Product Change Notification (PCN)

PCN #: 2B-2022

DATE: 2/14/2022

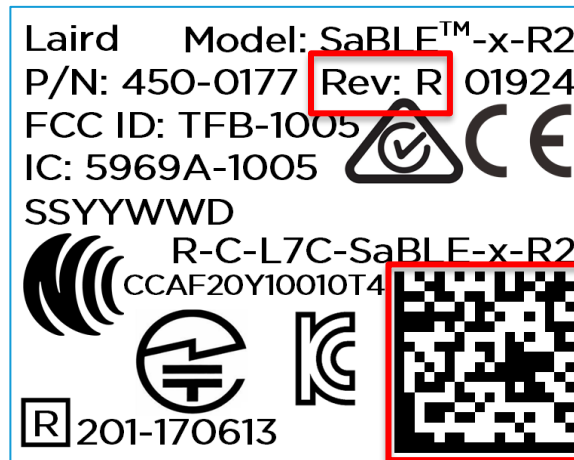
- Added 32KHz Crystal Substitute and corresponding load capacitance

- Adding substitutes to improve sourcing.
